About this Document

In this document, I am presenting the error analysis of Schematic and PCB design of the KiCAD assessment file. I have included the following datasheets and documents that I used as a reference to analyze the errors and make recommendations:

Figure 9. Linx uSP410 Series Recommended Layout.

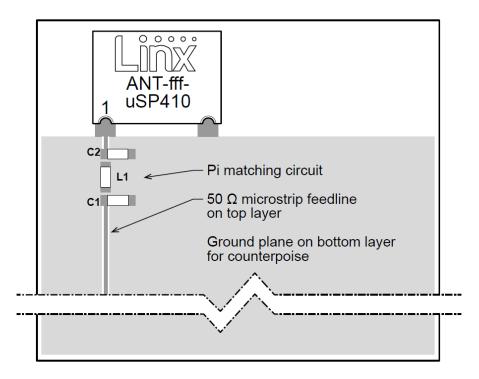
Looking at the antenna Datasheet, Linx specifies that the antenna is design to operated without any impedance matching circuit. However, the device has a high possibility of being subjected to a highly rough environment imposing various kinds of proximity effects, for which, matching may improve the end-product antenna performance. For matching network, Lnix recommends at least a 3-element surface mount matching pi network with two parallel capacitor and one serial inductor as shown in figure below:

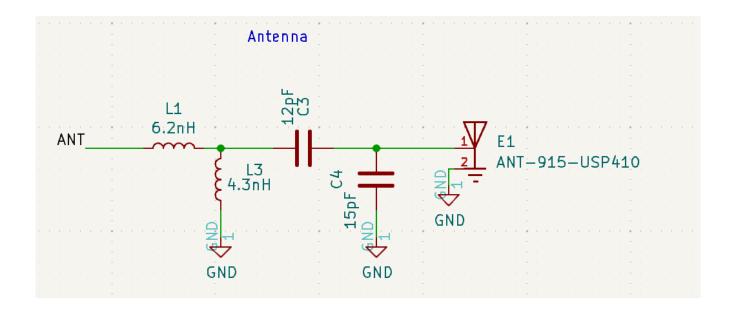
In the existing design, another type of network is used as shown below.

I would like to align with the recommendation provided by Linx datasheet with the following calculation for the values of inductors and capacitors that yields the presented frequency response in the figure below:

Frequency (F)	915 MHz •
Source resistance (RS)	50 Ω.
Source reactance (XS)	0 Ω •
Load resistance (RL)	50 Ω.
Load reactance (XL)	0 Ω •
Q factor	17
Circuit DC current	Pass DC Current ▼

Inductance (L)	1.0196 <u>nH ▼</u>
Source capacitance (CS)	0.05914 nF •
Load capacitance (CL)	0.05914 nF •

For the selection of components, first of all, the inductor availability was inspected (as it has availability for limited number of values only than compared to capacitor) for various Q factor values with appropriate frequency response, the resulting value was searched in the web application of electronic supplier (mouser electronics in this case) considering the package size of 0402 (priority given for this case) or 0603 and comparing various parameters, the following components for the matching network is selected:

Component	Quantity	Value	Link
Inductor	1	1 nH	https:// www.mouser.ca/ ProductDetail/ KYOCERA-AVX/ HLQ021R0BTTR? qs=RNZK %252BTbvcGGezGJ %2FSnTp8A%3D%3D
Capacitor	2	56 pF	https:// www.mouser.ca/ ProductDetail/ KYOCERA-AVX/ 0402ZK560FBWTR? qs=HoCaDK9Nz5c0Kb b2clqWWw%3D%3D

Sensor Section:

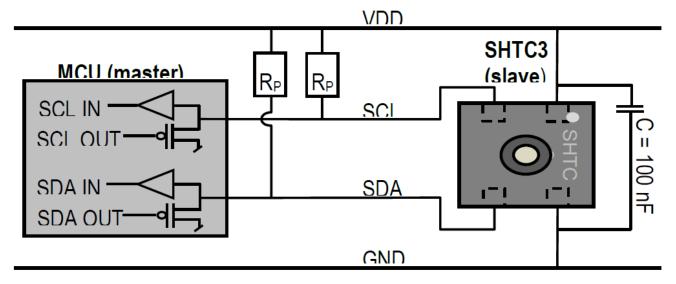
The sensor section consists of direct connection between the MCU's and Sensor's I2C interface. According to I2C standard, it is an open-drain NMOS(mostly) interface and requires a pull up resistor connected for each SCL and SDA line. Furthermore, the datasheet of the temperature sensor also recommends external pull-up resistors having the value of 10K on the lines.

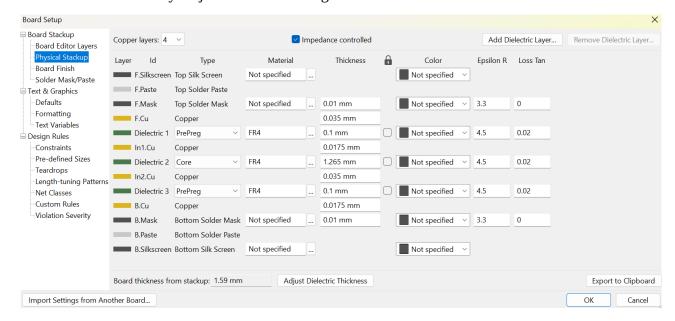
1. In the board setup options, i.e.: Board Setup -> Physical Stackup, the Impedance Controlled option was not checked. Checking this option before designing for RF design will ensure the Loss Tangent and relative dielectric constant (ε_r) will be added to the constraints. This will help in Trace Geometry Adjustments and Design Rule Enforcement.

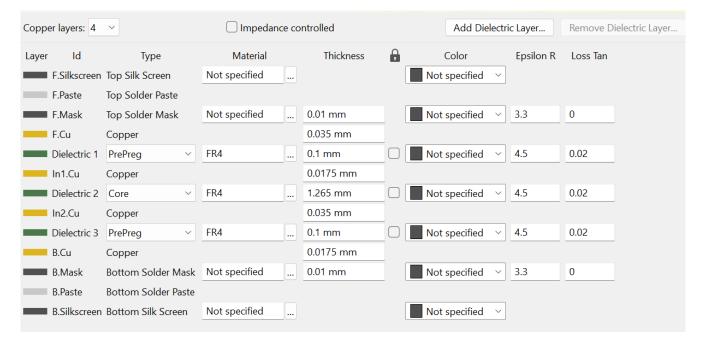
2. Since there is no particular manufacturer specified, referencing to the following available preconfigured Physical Stackup:

The trace width of the RF microstrip wave guide in the grounded co-planar wave guide configuration is calculated as under using the KiCAD calculator:

Based on the above calculation, the width(W) of the microstrip should not cross 0.19mm, however, in the current design, the width is 0.25mm. However, the spacing between the microstrip and copper planes (S) for optimum performance must be around three times the height of dielectric (3*0.1mm = 0.3mm being 0.19 minimum from above calculation) which seems to be satisfied in the design (exactly 0.3mm).

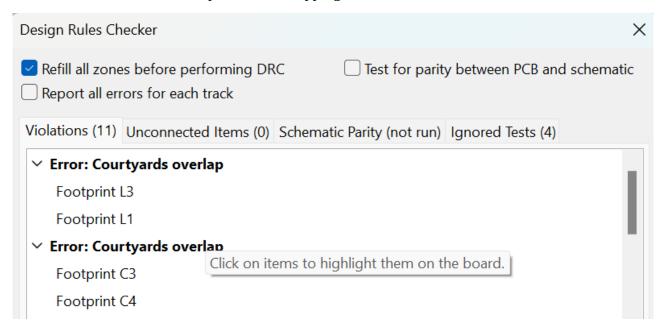
4. The maximum allowable distance between two vias in the via stitching is given by expression:

$V_L = 0.00983 \text{ m} = 9.832 \text{ mm} \sim = 10 \text{ mm}.$

The spacing between the vias seems to be fine, but, they are spaced irregularly. In my opinion, stitches spaced regularly all across the board may provide a better easy return path and improves the impedance and RF performance of a board in most of the cases. Also, increasing the spacing slightly to an allowed range can help in providing more spaces for routing signals, improves copper filled-zone area and some thermal improvements.

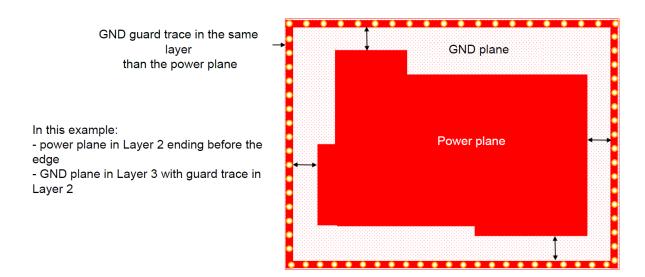
Even the curves with the continuous width (only if required) would be better than bending the RF microstrip wave guide at any angles.

8. The third layer from the top is the power plane. The Application Note AN5407 recommends power plane not to be routed at the edge of the board to avoid the unintentional electromagnetic radiations due to fringe fields. Ground plane must be put in all layers around the board and must be connected.

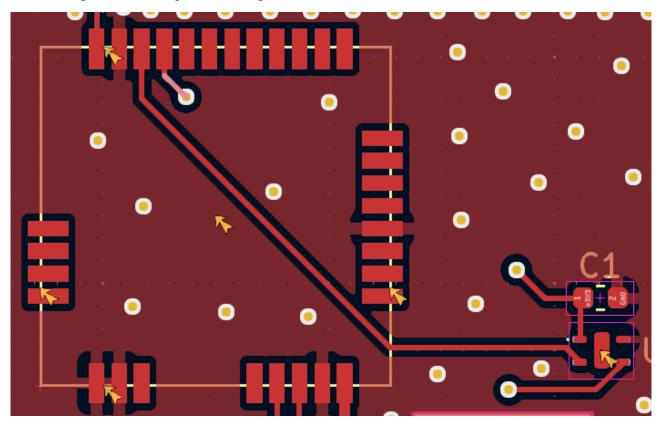
9. The filled copper zone at the bottom side of the RAK 3172 module acts as a thermal release as it is obvious that the microcontroller gets heated during its operation. Routing any traces that carries signal may cause signal loss or bit misrepresentation due to the temperature effect on the signal trace. To avoid routing the signal with net label I2C_SCL, the proper layout and arrangement of components along with the RAK 3172 module will be sufficient.

There is a similar case with routing for the signal trace with net label I2C_SDA, but, in this case the signal is transmitted to the bottom layer and again brought back to the top layer which may

not be required in this case as there is a plenty space for routing a signal with proper arrangements of all of the components. The use of via as in this case is unreasonable because via is used only when it is impossible to route a signal from top layer because the unavailability of a proper routing path from the source to the destination. Furthermore, this also violates the best practices for PCB design implementing I2C protocol which includes:

- For best performance, route the I2C traces on the same plane and above a reference plane (GND, Ideally or plane that has the same voltage as I2C interface), don't cross splits.
- Keep distance between the traces (SCL and SDA must be around 3 times the height of the dielectric)
- Keep traces as short as possible.

Figure 4: Decoupling of the sensor from heat sources in the PCB minimizes the influence of internal heating on the sensor.

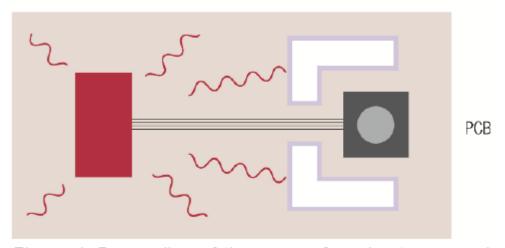
10. The placement of the temperature and humidity sensor at the center of the board is not optimum in my opinion as the copper plane acting as a thermal release near the microcontroller module can introduce extra heat causing measured temperature to be slightly higher than actual value. It should be placed near the edge of the board with a fair amount of clearance from the filled copper zone where it is free to sense the surrounding temperature. As the design guide also suggests this.

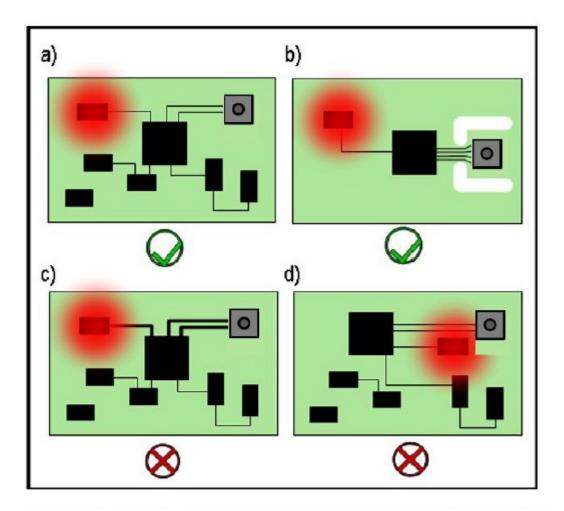
Even the width of the traces connecting to the sensor must also be as thin as possible. In short, the design guidelines recommended by the sensor manufacturer should be followed as much as possible as shown below:

Figure 10: The sensor may be thermally decoupled from the PCB by small PCB connections or with a flex.

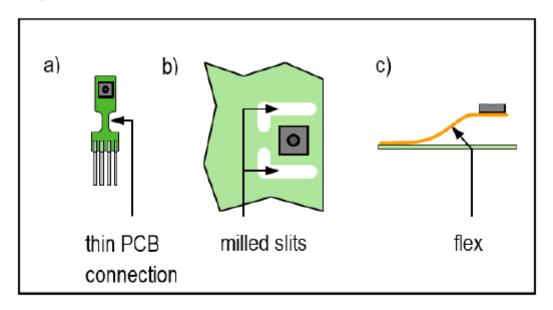
In order to get a good decoupling of the sensor and the housing / PCB the heat conduction needs to be reduced as described in the heating section above (see *Figure 10*).
